Response to

Request for Additional Information No. 245 (2981, 3036), Revision 0

U. S. EPR Standard Design Certification

**SRP Section: 03.09.02 - Dynamic Testing and Analysis of Systems Structures and
Components**

Figure 03.09.02-43-1—Interaction of Flow over a Cavity

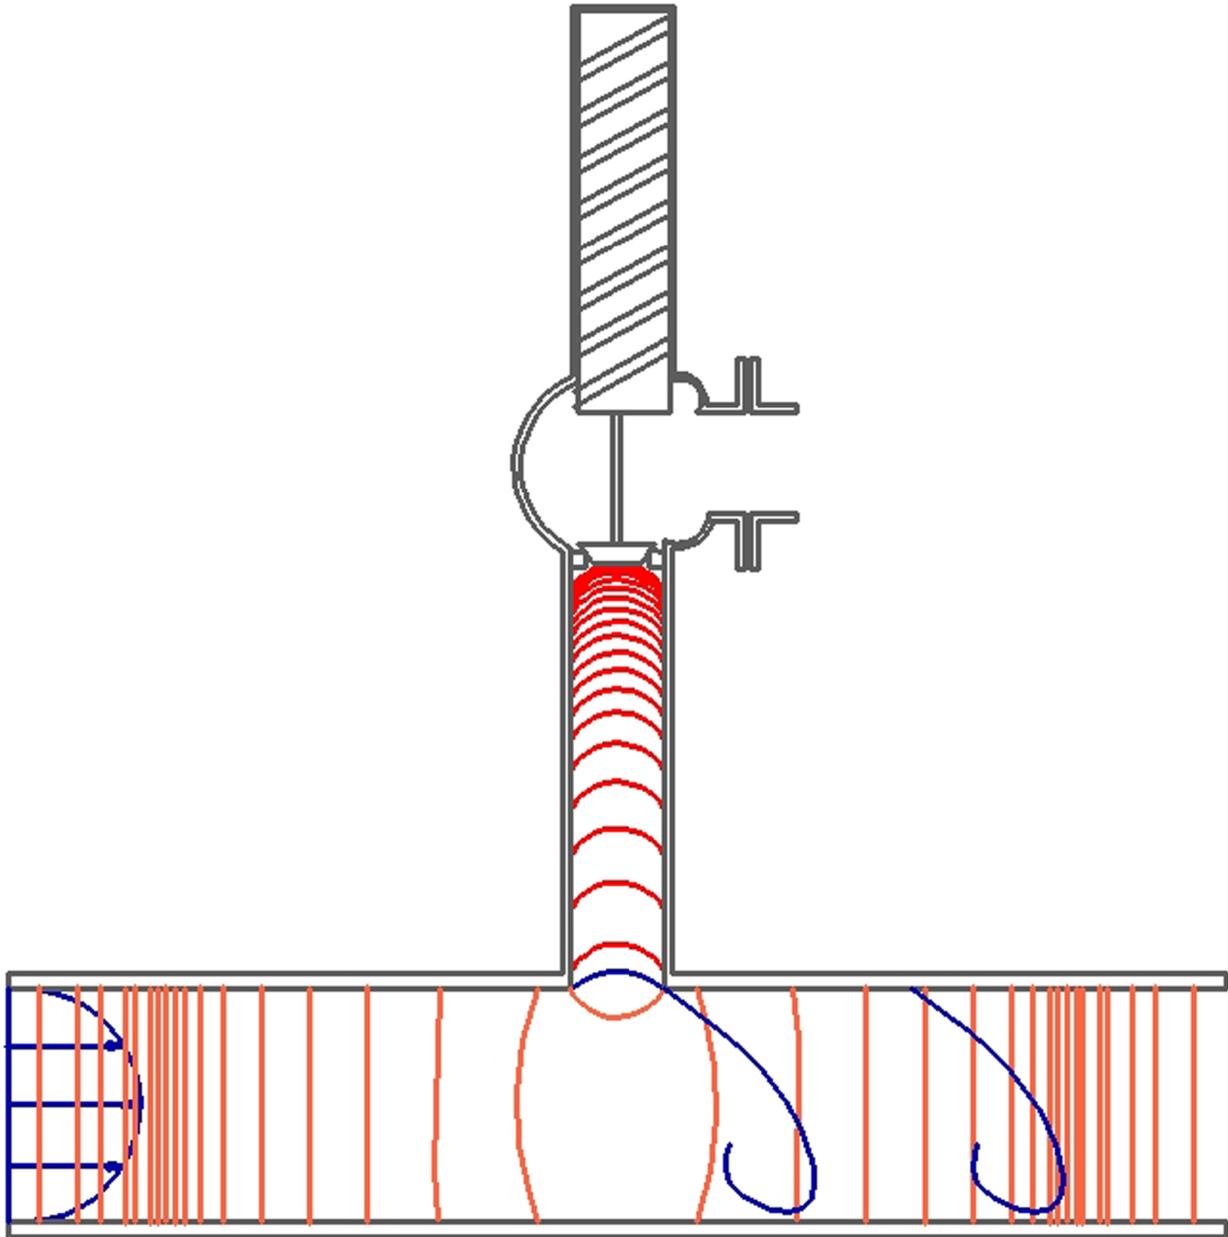
In **RAI Question 03.09.02-17**, the staff requested the applicant to justify the use of representative trains instead of all lines encompassing the RCS in the assessment of flow-excited acoustic and structural resonances or other self-excited responses given that flow-excited acoustic and structural resonances are sensitive to small changes in the construction of even supposedly identical systems. The staff reviewed the applicant's response and was unable to determine how a problem will be localized. As a follow-up, this RAI is initiated and requests the applicant to explain how they will localize a problem area so that corrective action can be taken. Further, flow excited acoustic resonances are sensitive to small changes in plant construction and operating conditions. The applicant has only indicated plans to test "representative" piping trains at full-power conditions. Sensitivity to small changes suggests that so-called representative piping trains will not be "representative." Additionally, at conditions just below and just above that range of conditions where the lock-in occurs, local vibratory response can be high without coupling system wide. Measurements schemes that depend upon system wide response to determine unacceptably high response may not detect locally high levels. In addition, the applicant is requested to describe plans for assuring that measuring representative piping systems will capture excessive vibration in the remaining piping systems.

Shear wave resonance of valve cavities occurs when the standing acoustic wave in the valve's cavity couples with the vortices shedding off of the leading edge of the valve cavity's mouth (see Figure 03.09.02-43-1). When the vortex shedding frequency becomes close to or equal to the acoustic frequency of the cavity, then high oscillating pressures may develop. The resulting resonance pressure-flow oscillation can travel through the entire affected piping system with little attenuation. The oscillating pressure amplitudes inside the valve can be much greater than the main piping line dynamic pressure. If these acoustic instabilities in the flow fields resonate with the structural frequencies of the RCS internal components, then high dynamic loads can be created that normally result in high cycle fatigue failure.

To prevent the RCS from experiencing dynamic loads created by sources of acoustic resonances, piping systems attached to the RCS will be designed such that the generation of flow excitation in the cavities of safety relief valves, standoff pipes for valves and branch lines, etc. is not possible. The methods described in this response will be used in the design and analysis of piping systems attached to the RCS to prevent the generation of this source of flow excitation. If standoff pipes are found to be susceptible to acoustic resonance, as determined by a Strouhal number between 0.3 and 0.6, through the entire operating range of flow, then measures will be taken to redesign the piping so that acoustic resonance will not occur. There are other options in the design, such as the position of the safety relief valve on the main piping line, that can be adjusted to effectively eliminate the shear wave resonance, and other resonance suppression techniques can be deployed if an acoustic resonance problem is identified.
